# **2001 - 2003 Corvette: Service Manual Update: Revised Wheel Drive Shaft Outer Joint and Seal Replacement and Wheel Drive Shaft Inner Joint and Seal Replacement Procedures**

**Number:** 03-04-95-001 - (01/09/2003)

**Models:** 2001-2003 Chevrolet Corvette

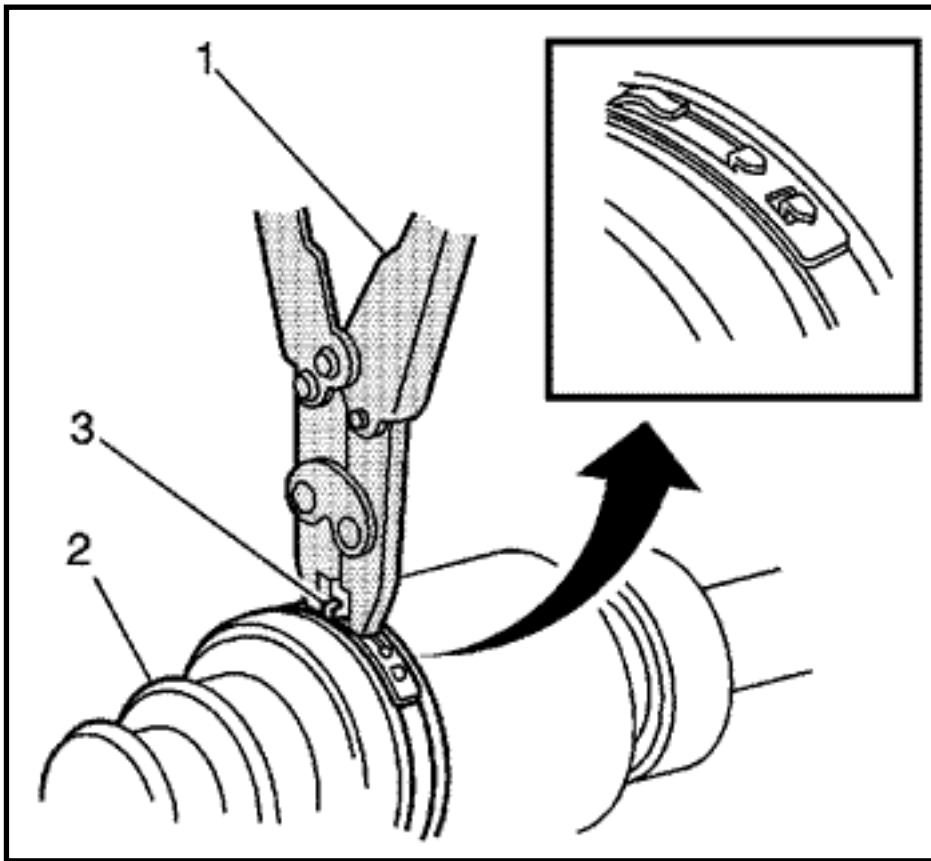
Because of a mid-year change in 2001, the large diameter clamp is now a low profile design, instead of the Omega clamp design. The new design clamp requires the use of Special Tool J 46588 to install. The following steps effect 2001 model year vehicles with the second design clamp and all 2002 and future model year vehicles.

Align the following items while latching:

- The wheel drive shaft inboard seal (2)
- The tripot housing
- The large seal retaining clamp (3)

Using the J 46588 (1), latch the large seal retaining clamp. Ensure that the latching tangs are fully engaged in the large seal clamp band.
